Motion: To address the concerns of the committee expressed in comments #149 (Thompson) #33(Dove), #64 (Barrass), specifically, and low-power concerns generally, the following changes will be made to the draft.

## 55.5.4.5 Short Reach Mode

Figure 1. Short reach test channel

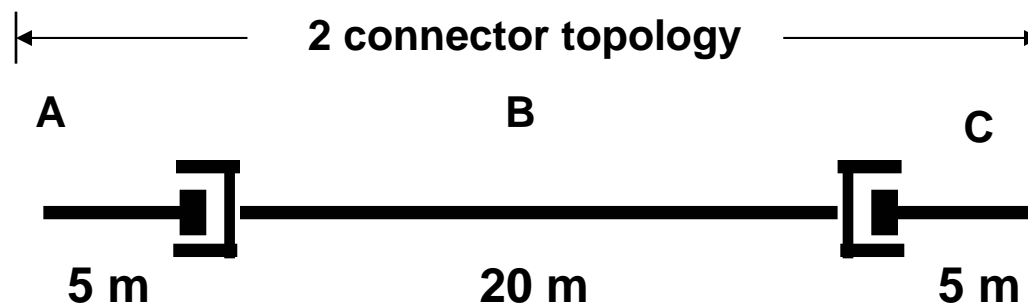
One short reach test channel specification is consistent with the transmission characteristics of a cabling link of 30 meters consisting of two connectors, 10 meters of cable cord, and a horizontal cable distance of 20 meters, that meets the ISO/IEC 11801 Category 7 component specifications.

One short reach test channel specification is consistent with the transmission characteristics of a cabling link of 30 meters consisting of two connectors, 10 meters of cable cord, and a horizontal cable distance of 20 meters that meets the Category 6A component specifications.

# 55.5.4.5.1 Short reach test channel

**Category 7- 30 meters,10 meter patch ,20 meter horizontal,  
2 connectors**

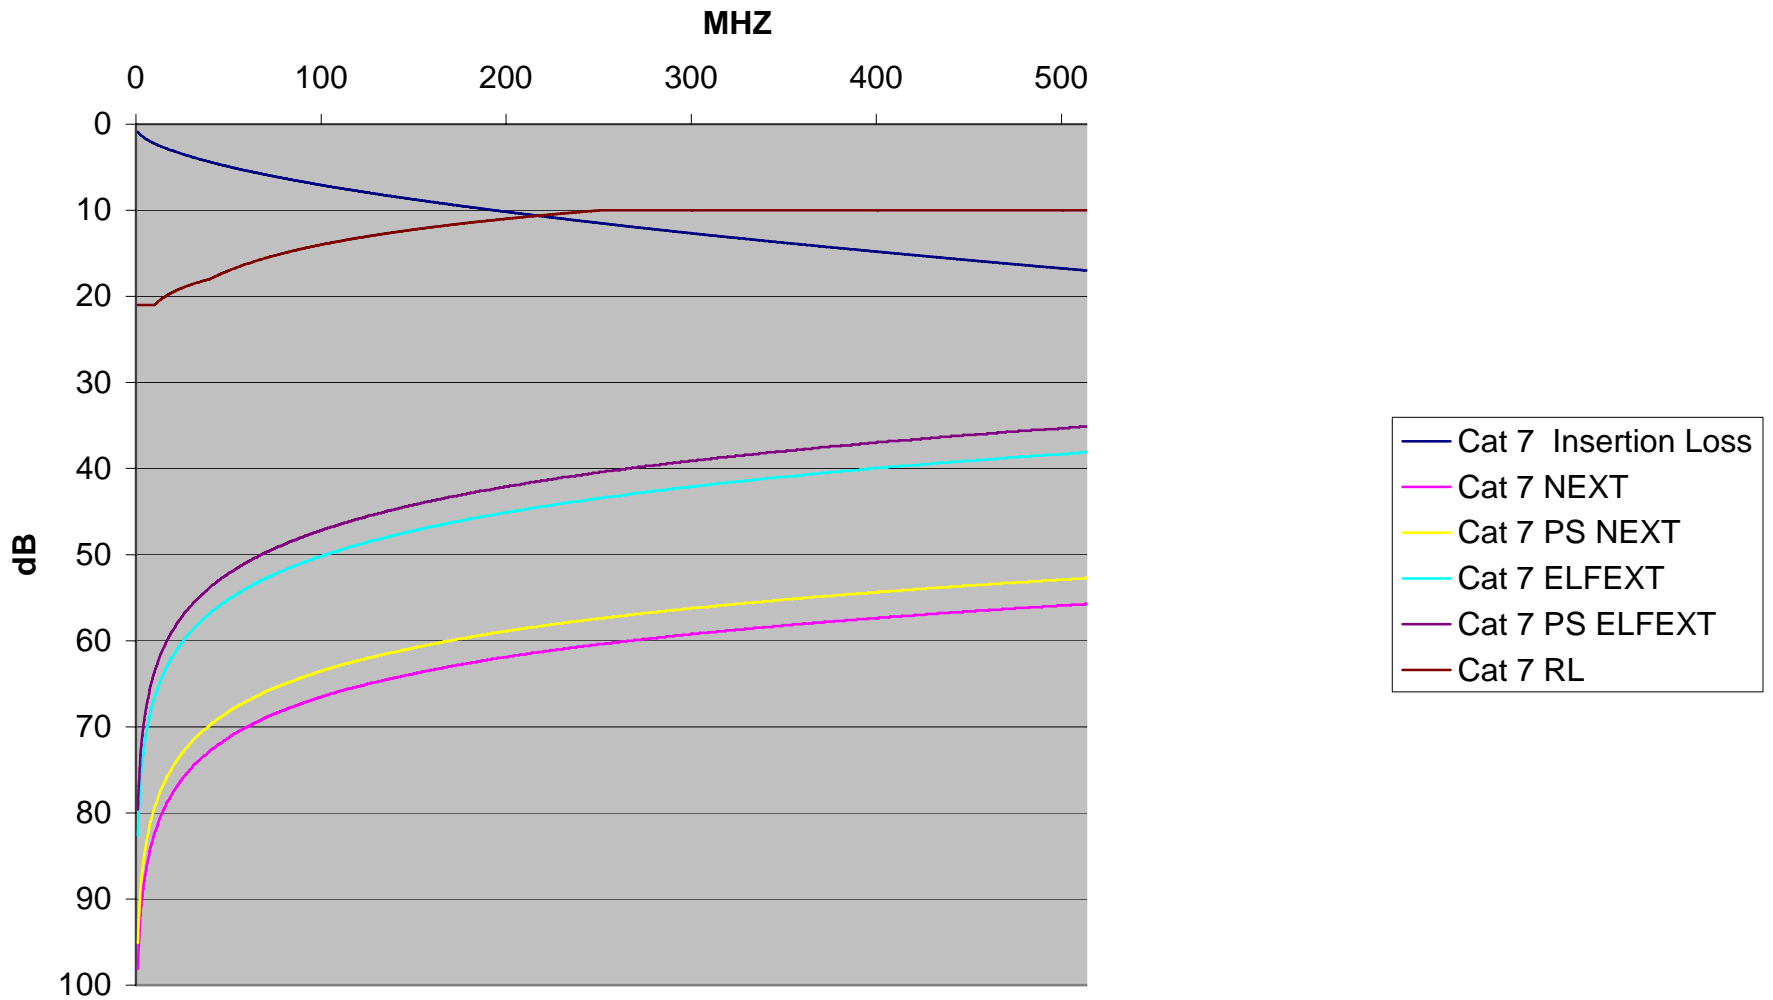
**\*Category 7 – 2 connectors-10 m total patch cord-20 m horizontal cable**

### Category 6A - 30 meters,10 meter patch ,20 meter horizontal, 2 connectors

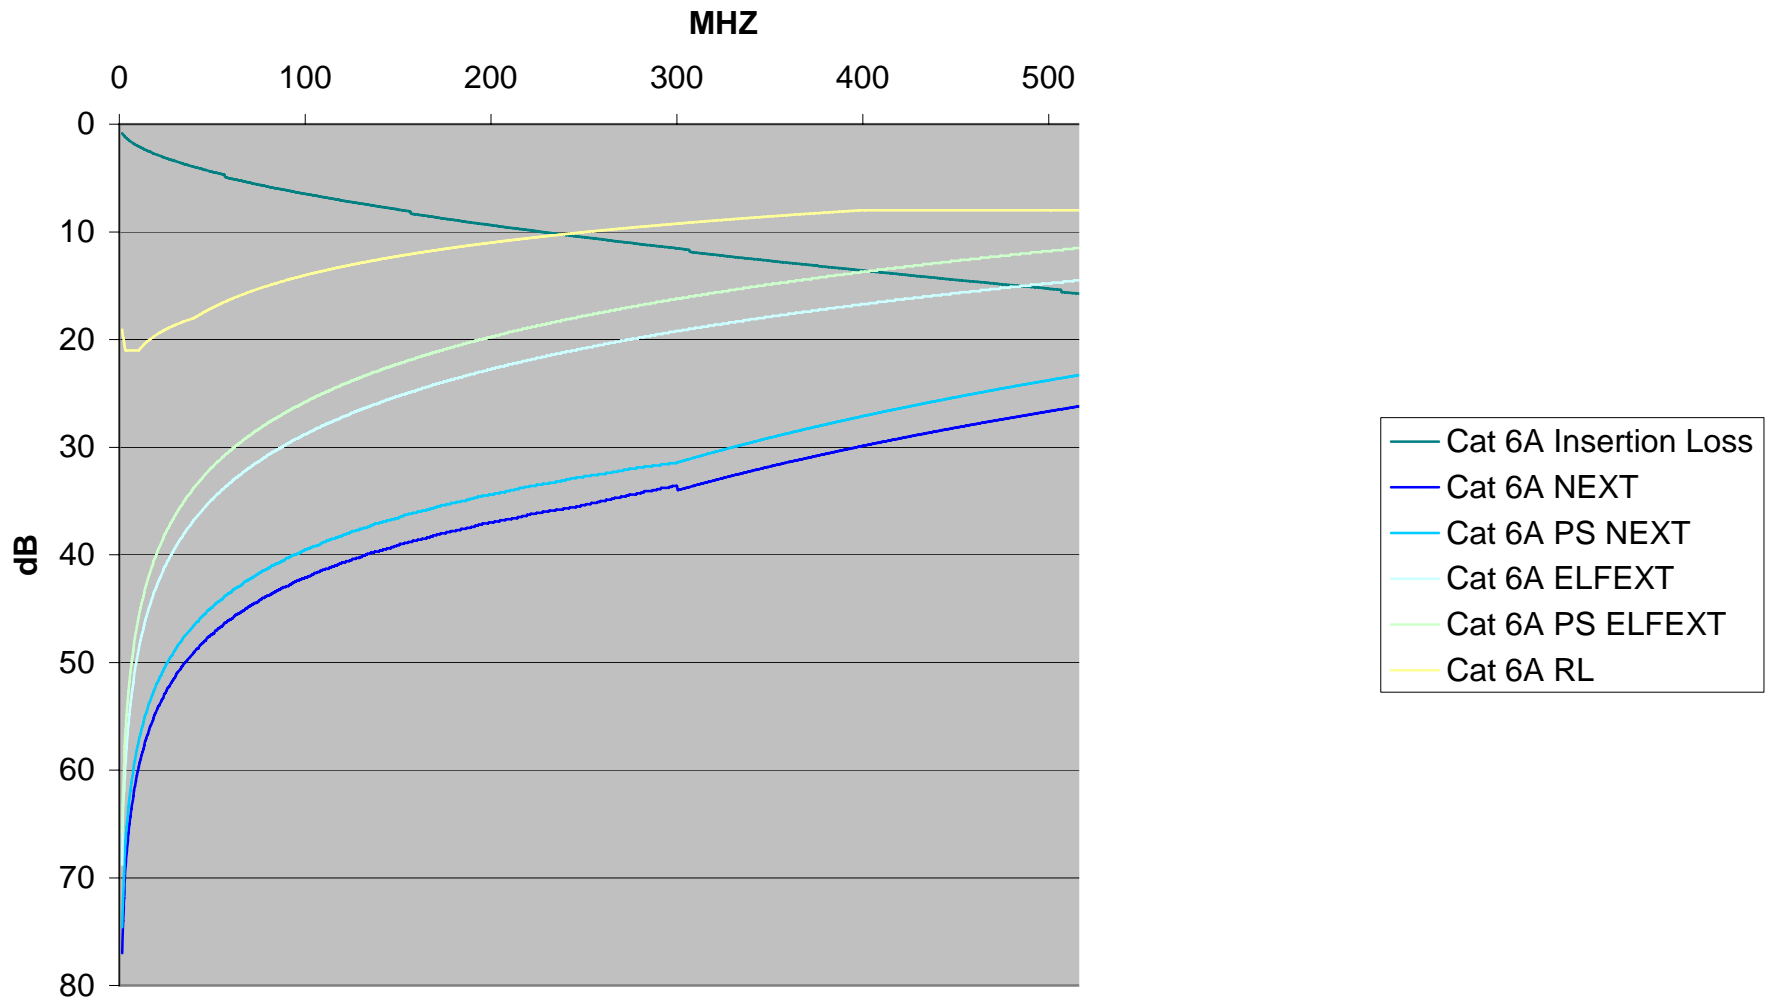
**\*Category 6<sub>A</sub> – 2 connectors-10 m total patch cord-20 m horizontal cable**
